**ADDENDUM  
NO. 02**

**March 14, 2022**

**Warren Central High School Phase 3 Renovation and Addition  
9500 E. 16<sup>th</sup> Street  
Indianapolis, IN 46229**

This Addendum consists of Pages ADD 2-1 through ADD 2- 5, and attached CSO Architects Addendum No. 2 , dated March 13, 2023, consisting of 11 Pages, Specification Section 02 01 00 – Maintenance of Existing Conditions, and Addendum 2 Drawings: C101, C102, C401, C501, C502, C503, LD001, L101, L106, L201, L206, L301, L306, S201PRT, S202PRT, S501, S601, AD201N, A201M, A201N, A202N, A211G, A211M, A211N, A401, A404, A423, A431, A432, A600, A601, A602, A603, A611, A612, A701, A702, A703, A800, A801F, A801J, A801M, A801N, A801P, A801R, A801T, A802F, A802N, A802P, A802R, A802T, A900A, A900B, A901K, A902U, A903, A904, A905, A906, MD201F, MD201H, MD201J, MD201K, MD201L, MD202HJ, MD202N, M201F, M201J, M201K, M201L, M201N, M202HJ, M202N, M211F, M211H, M211J, M211K, M211L, M211N, M212HJ, M301, M303.

3.37 SHEET A702 – ENLARGED RESTROOM PLANS

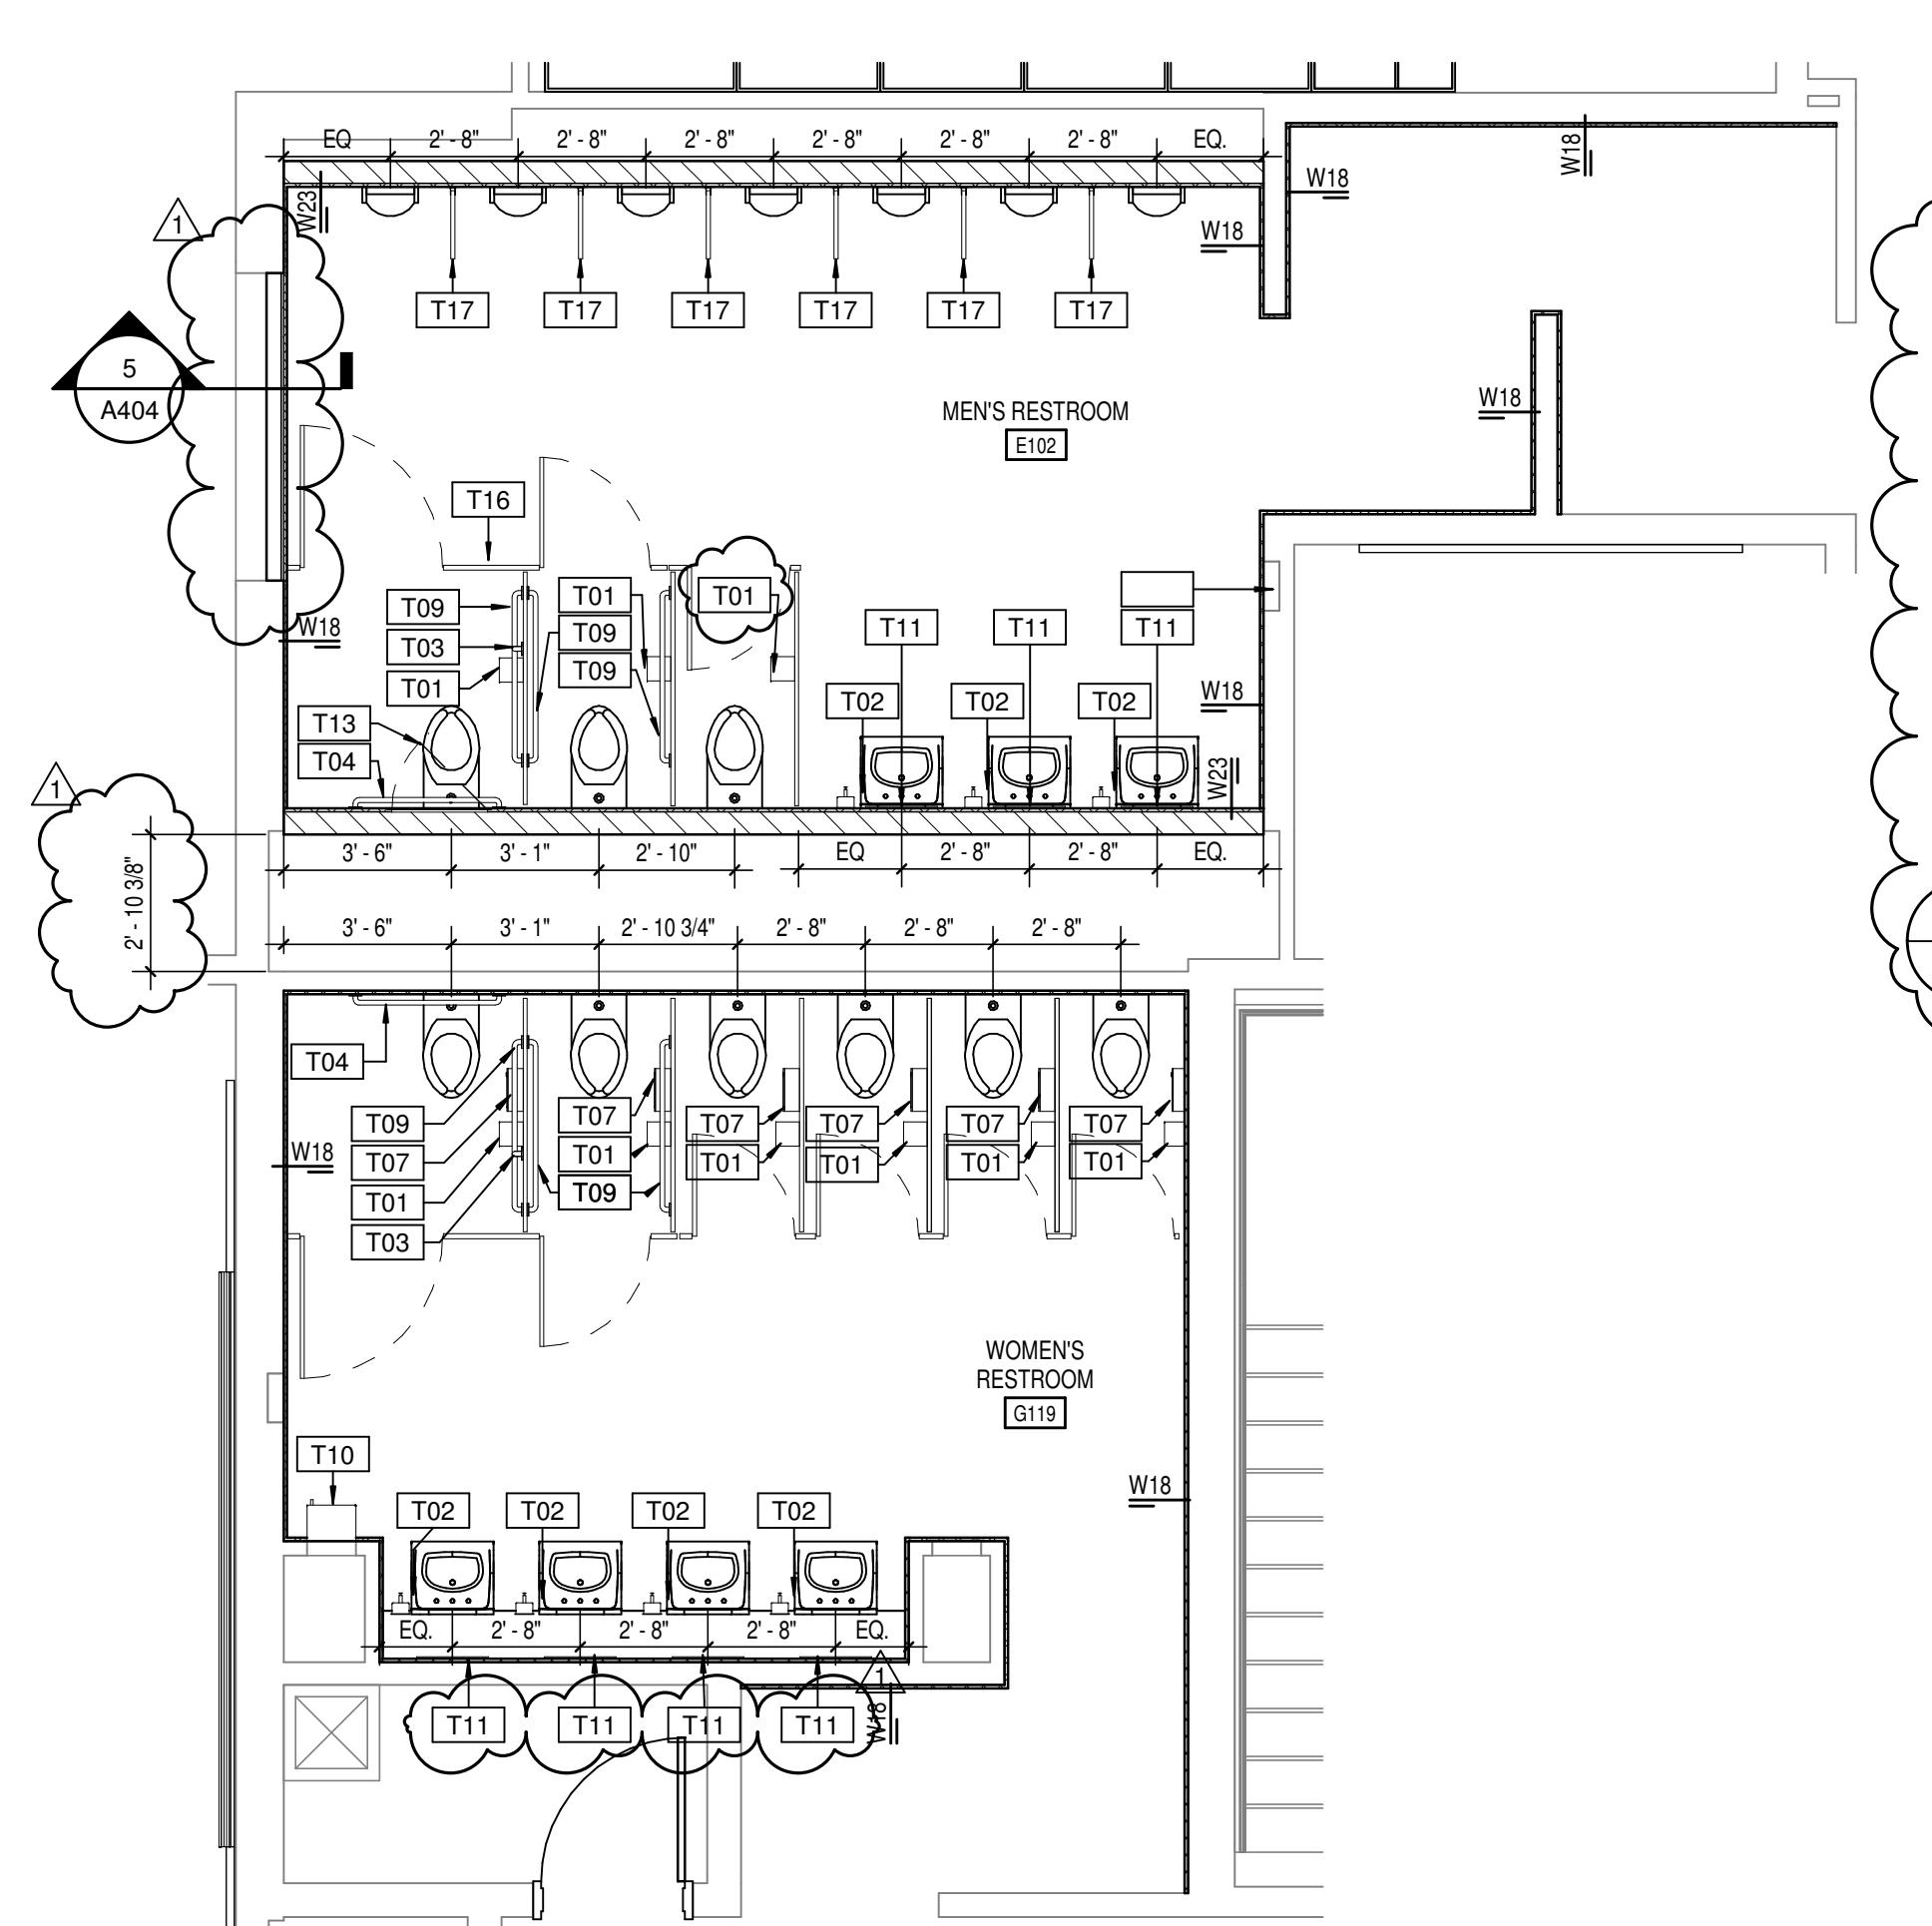
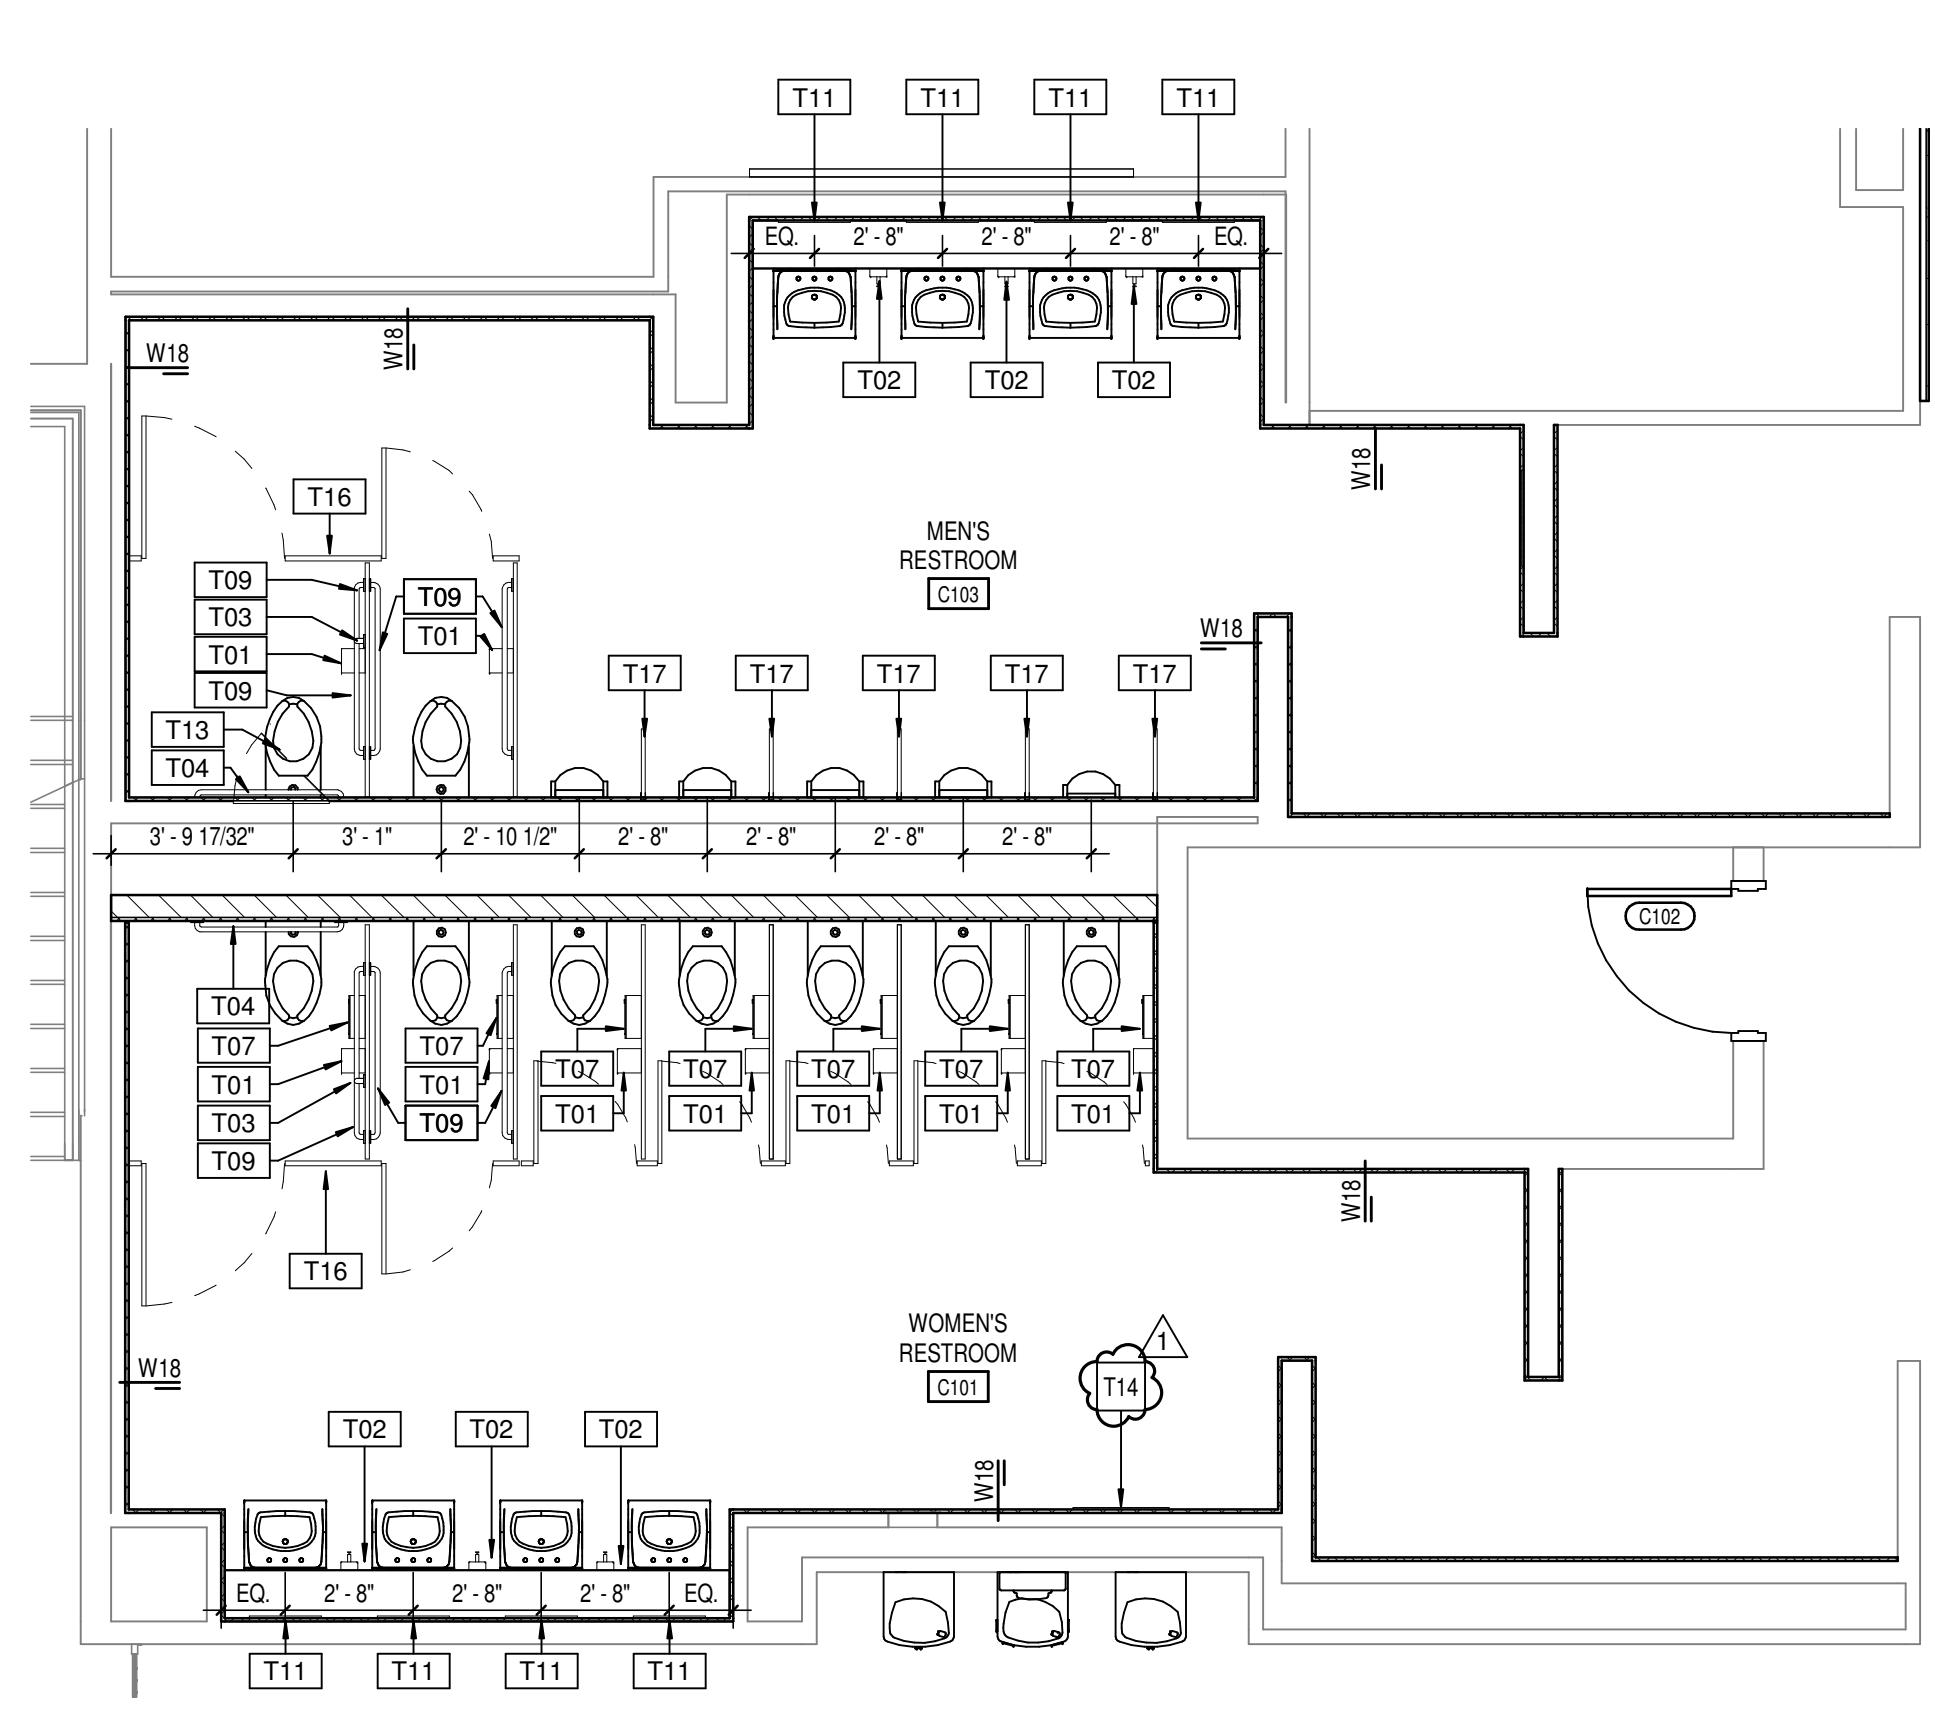
A. REVISE annotation and dimensions as indicate on attached, re-issued Sheet A702.

3.38 SHEET A703 – ENLARGED RESTROOM PLANS

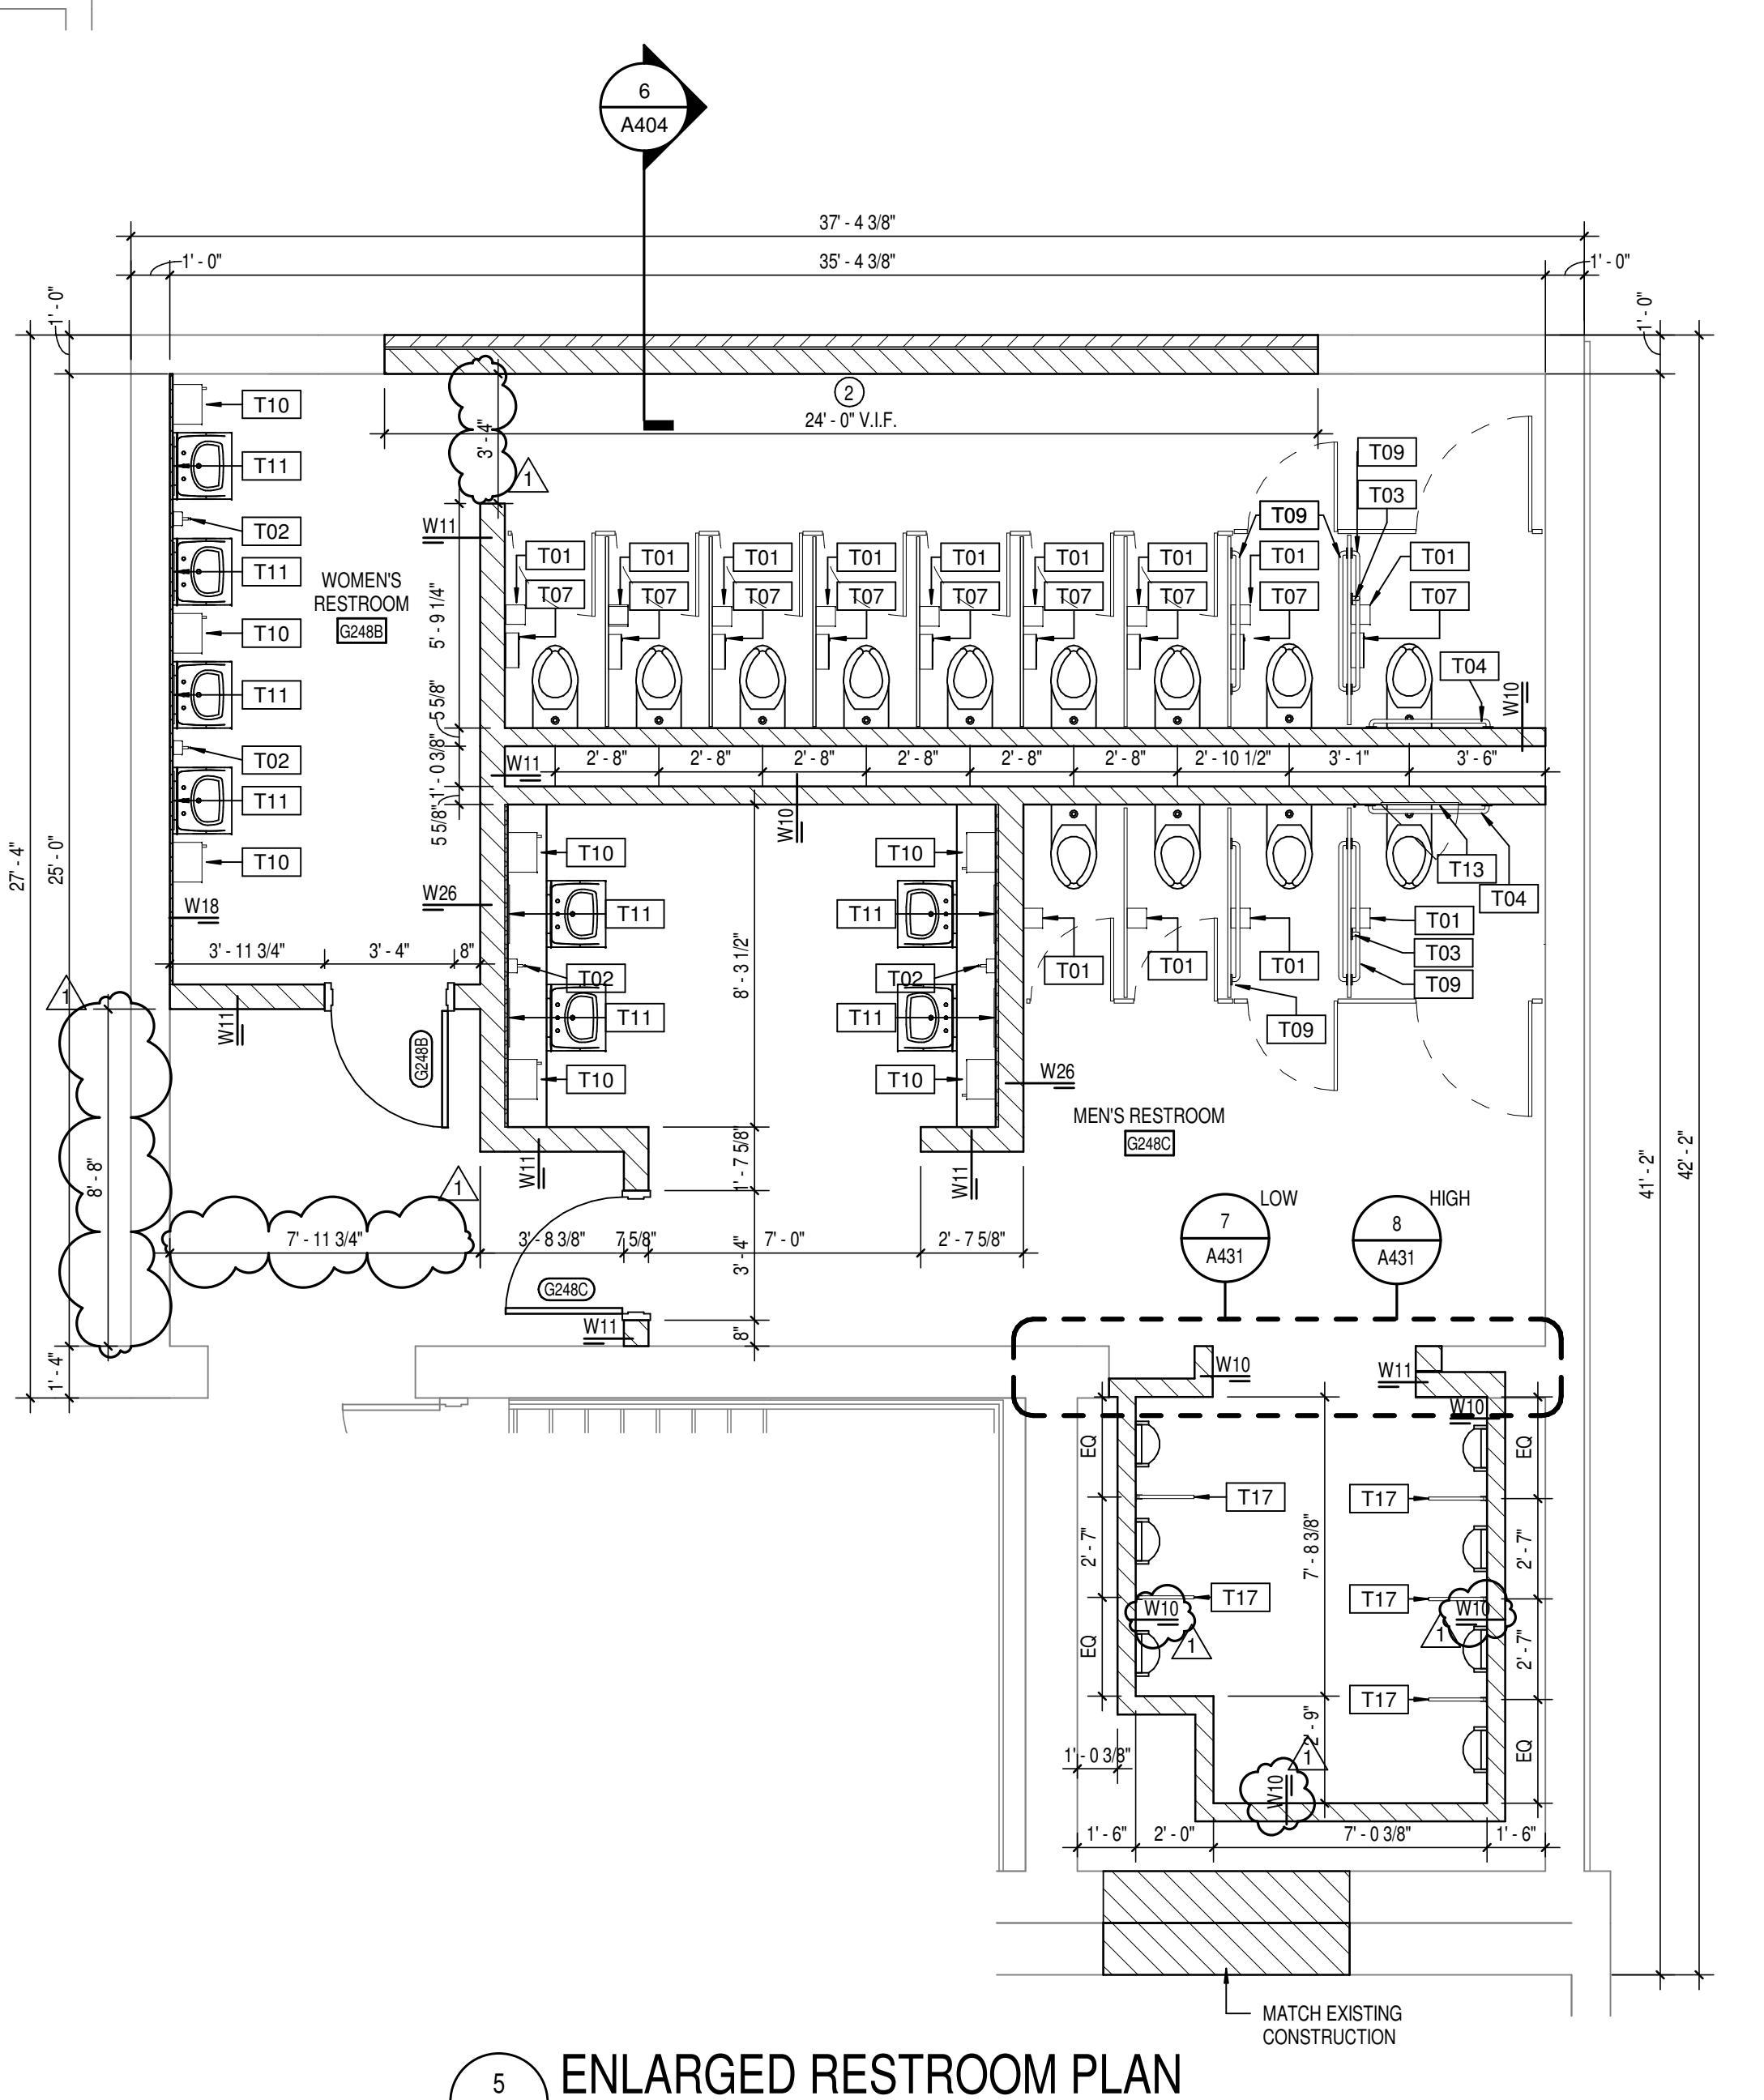
A. REVISE annotation and dimensions as indicate on attached, re-issued Sheet A703.
